**Ivas Environmental
Environmental Sciences
Wetlands and Planning Services**

**City of Boston Conservation Commission
Boston City Hall
1 City Hall Square
Boston MA 02201**

RE: MA DEP File #: NE - 006-1816, 155 Porter Street, East Boston

This letter covers the attached package of information provided to the City of Boston Conservation Commission. It is written as a response to Mr. Moreno's comments of 03 Nov 21 regarding the proposed project at 155 Porter Street.

3 BUILDING SECTION
A-302 3/32" = 1'-0"

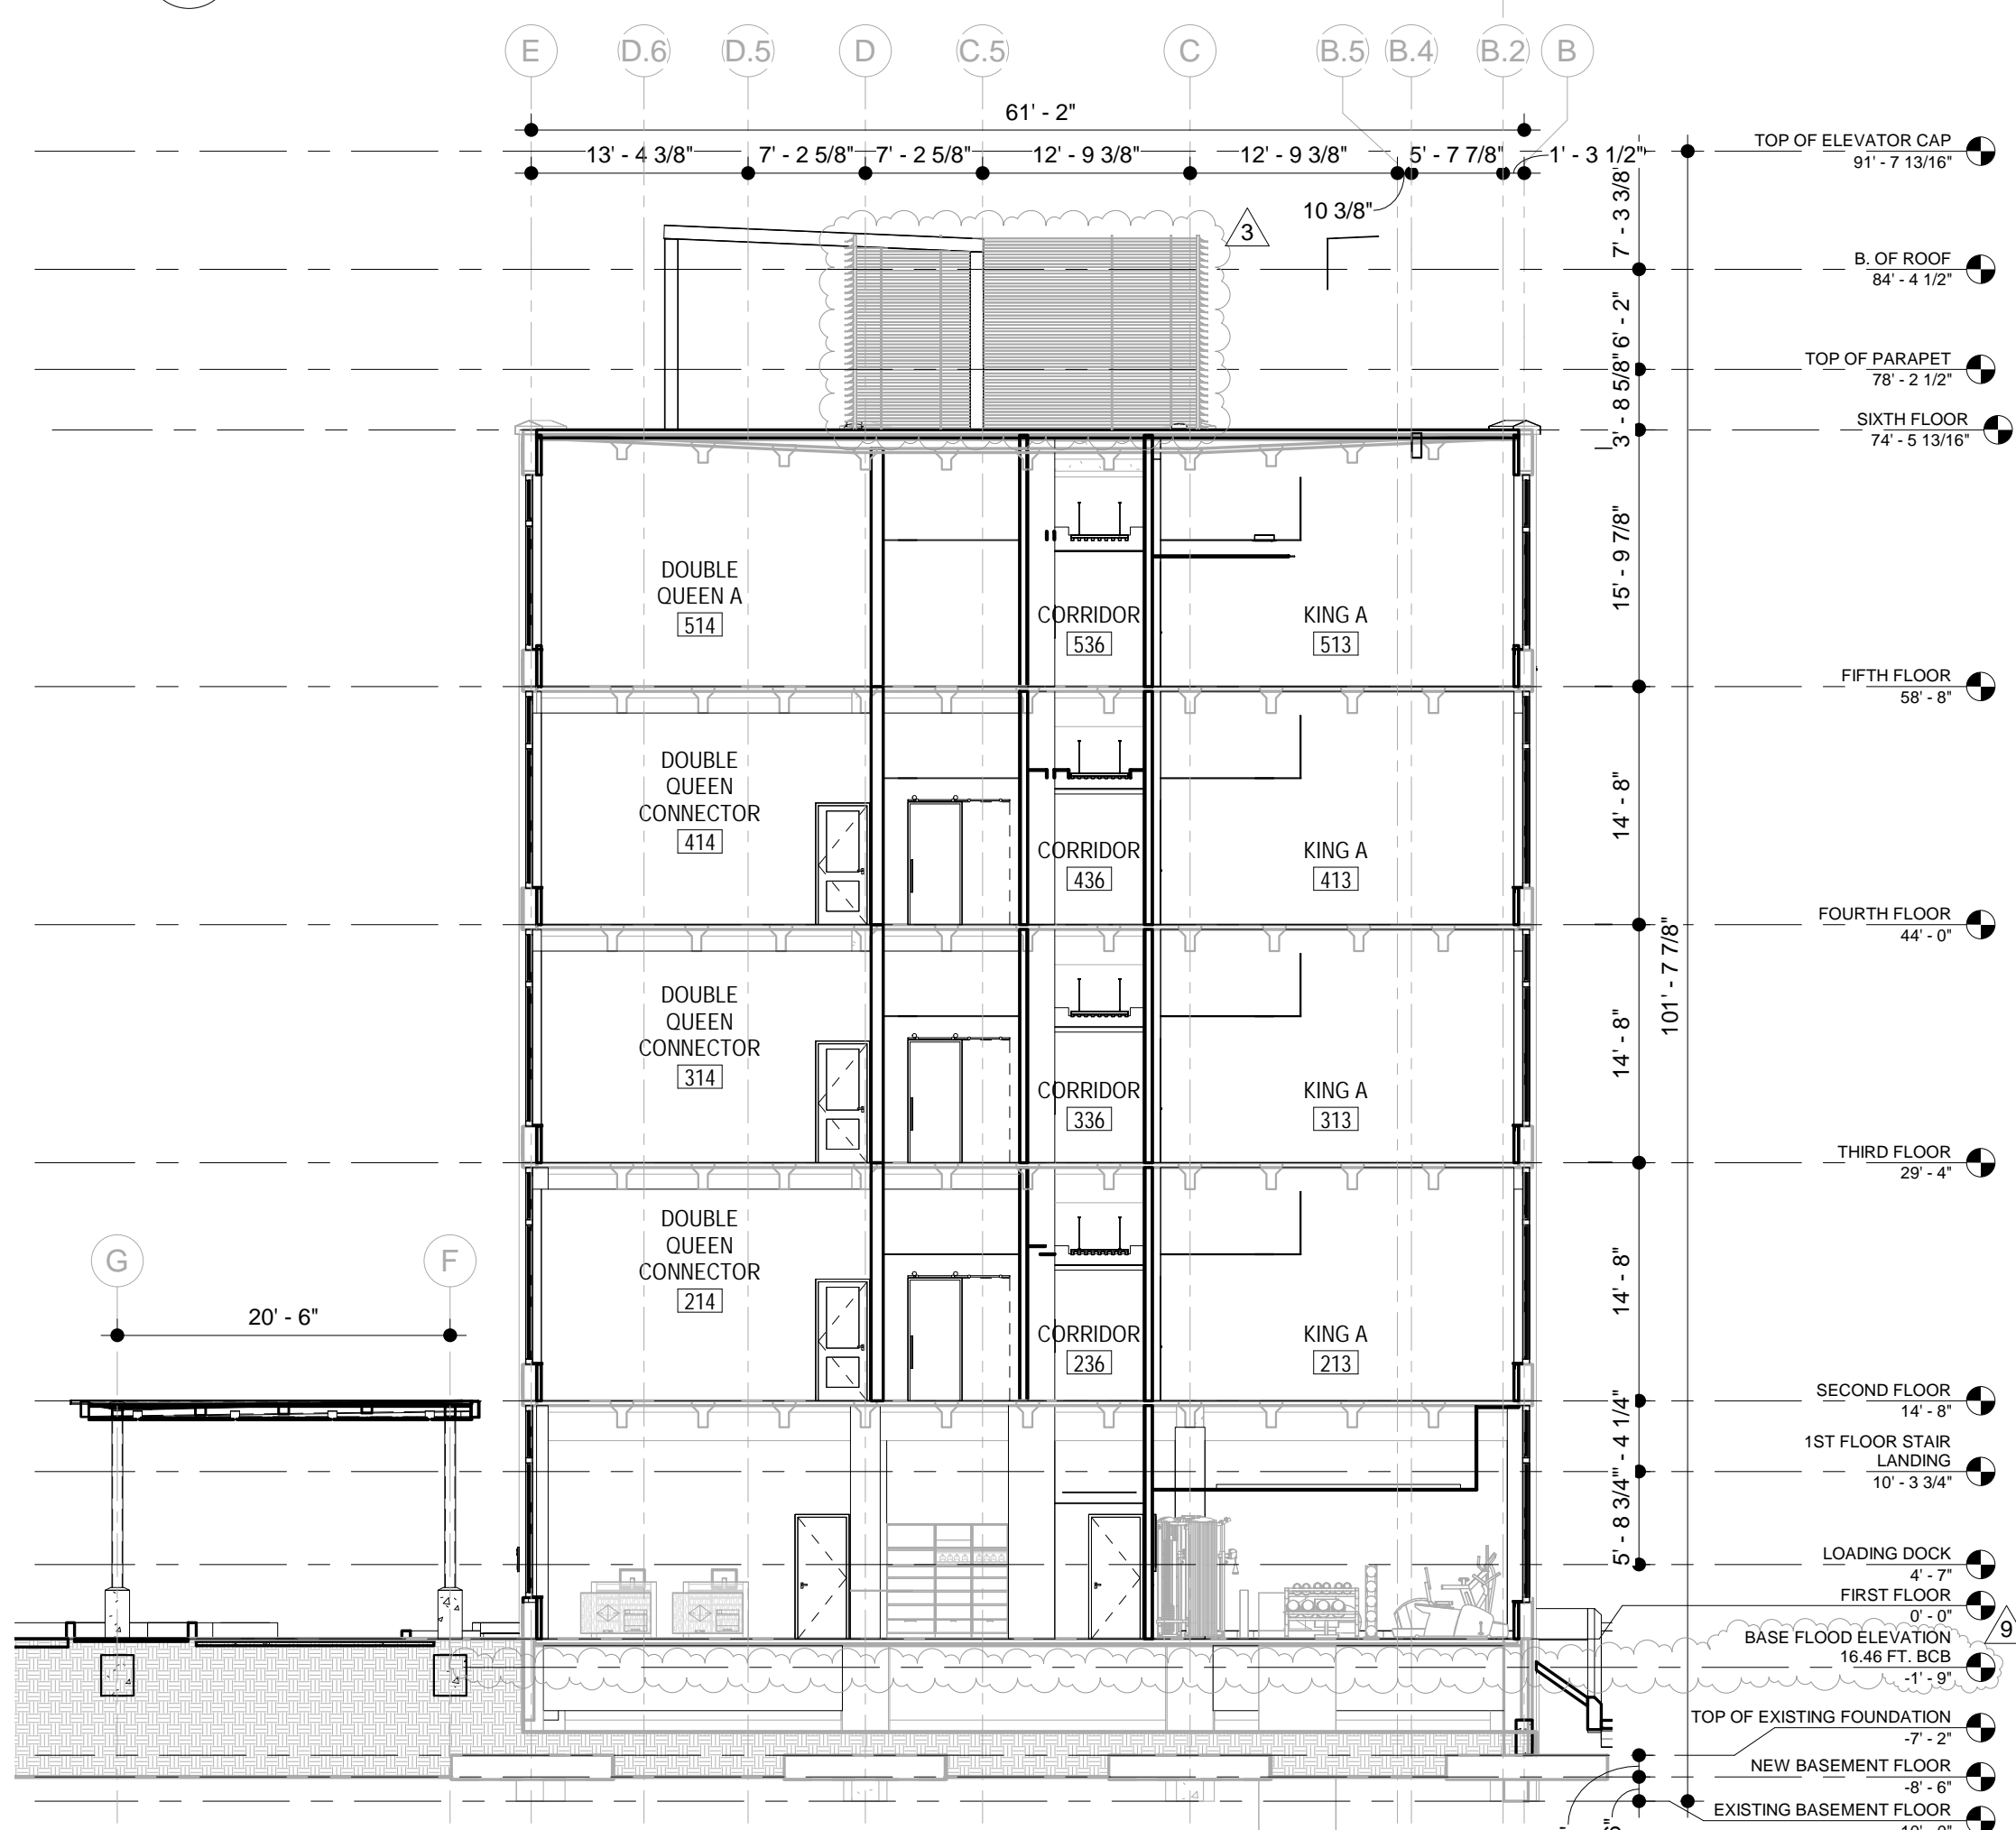
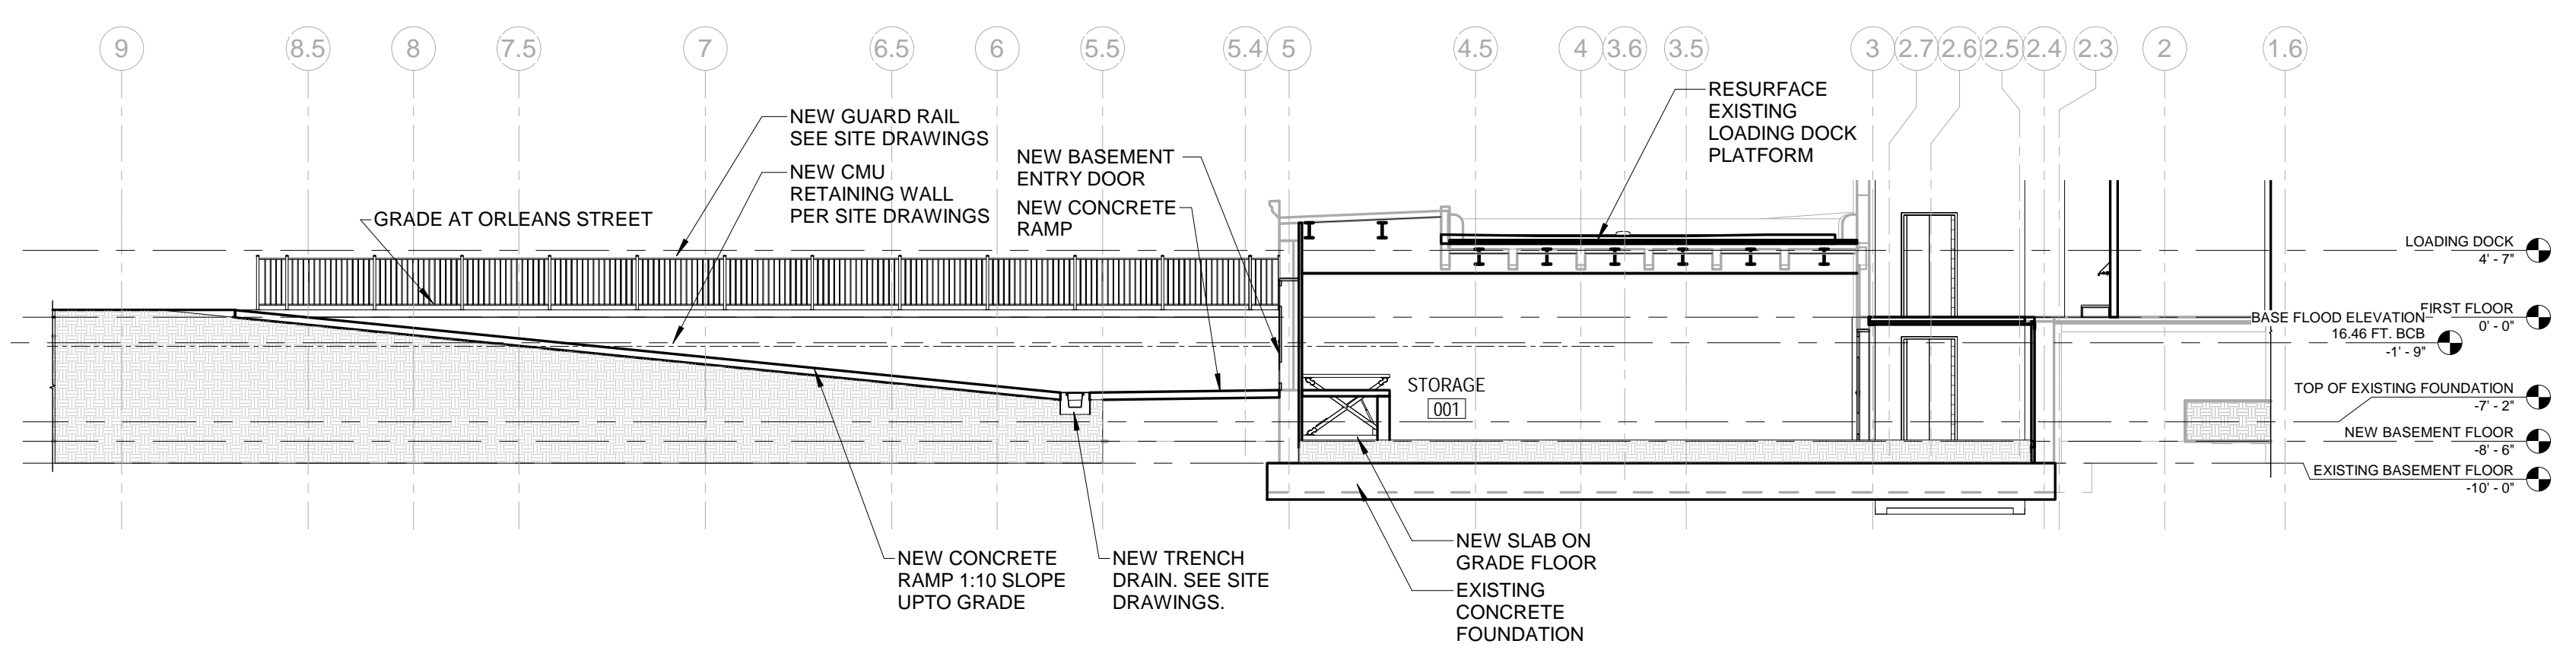
8. Please also include the base flood elevation line on the building section plans.

The base flood elevation has been provided on the building section plans attached.
